**STAFF PAPER**

# **Review of Sacramento Municipal Utility District's 2018 Integrated Resource Plan**

August 2019 | CEC-200-2019-014

**Figure 1: SMUD and CEC Energy Forecasts 2018 to 2030 (GWh)**

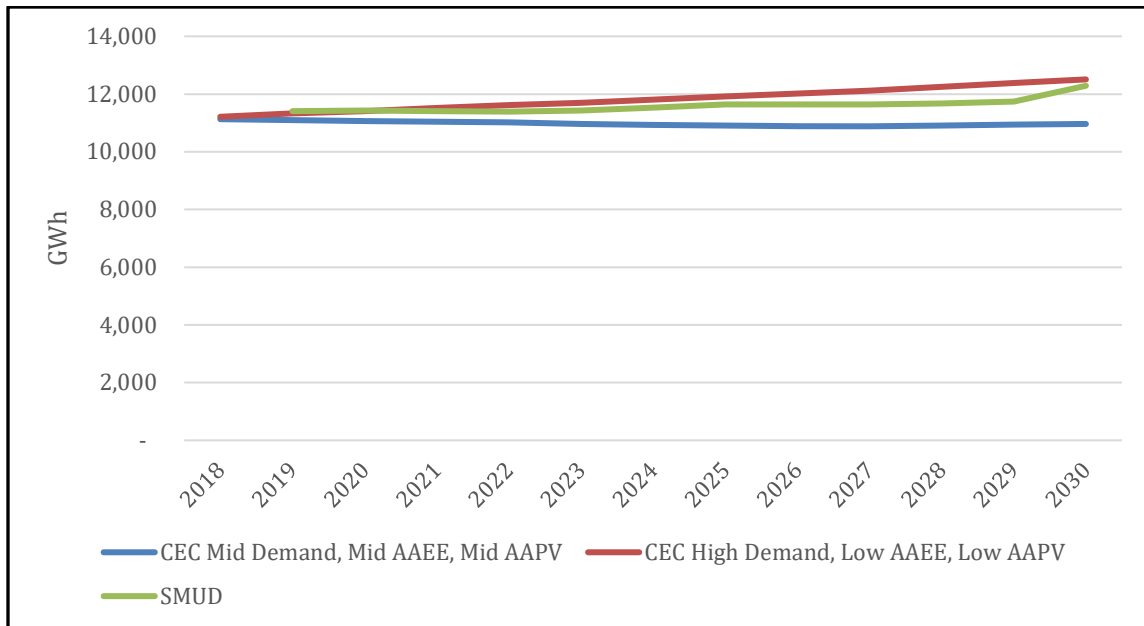
As shown in **Figure 1**, SMUD’s demand forecast is between the CEC’s 2018 Mid Demand, Mid AAEE, Mid AAPV IEPR demand forecast and the 2018 High Demand, Low AAEE, Low AAPV IEPR demand forecast.<sup>7</sup> SMUD expects slow growth in its energy demand over the forecast period. Growth in EV numbers and building electrification will increase energy demand, but that is expected to be offset to some extent by slow growth in housing stock and business activity, along with increases in customer-sited solar and battery storage. SMUD’s energy demand is forecast to increase from 11,404 GWh in 2019 to 12,296 GWh in 2030.

**Figure 2: SMUD and CEC Peak Forecasts 2018 to 2030 (GWh)**

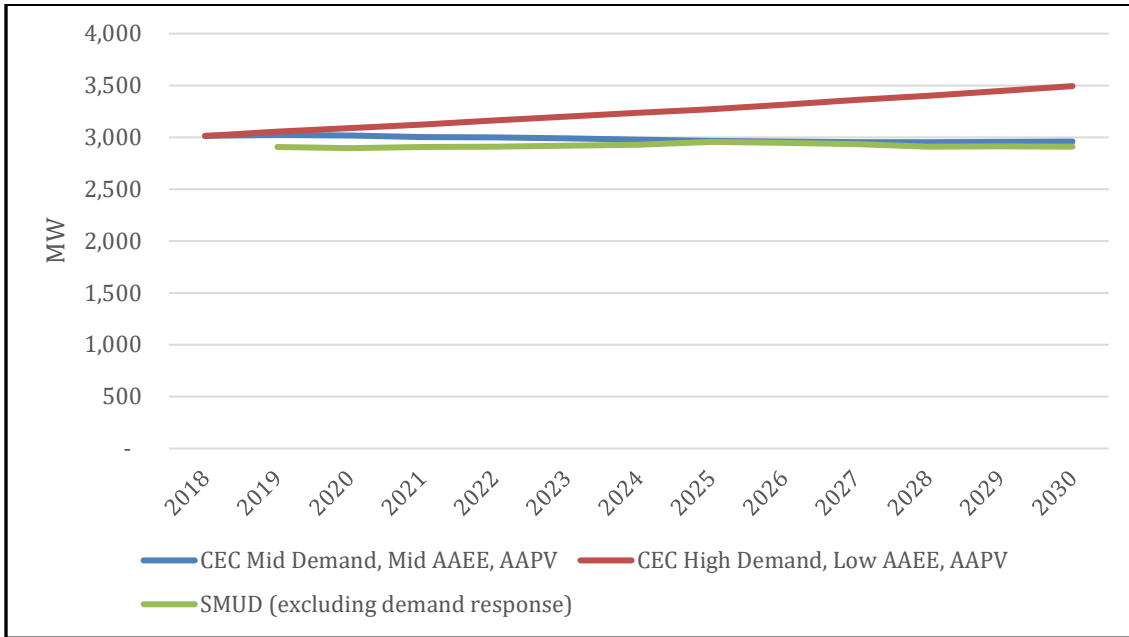
As shown in **Figure 2**, SMUD’s peak load forecast is slightly lower than both of the CEC’s peak load forecasts. In contrast to SMUD’s energy demand forecast, SMUD’s peak load is forecast to be flat through 2030. More widespread implementation of TOD rates is a key factor that will contribute to keeping SMUD’s peak load flat through the forecast period.
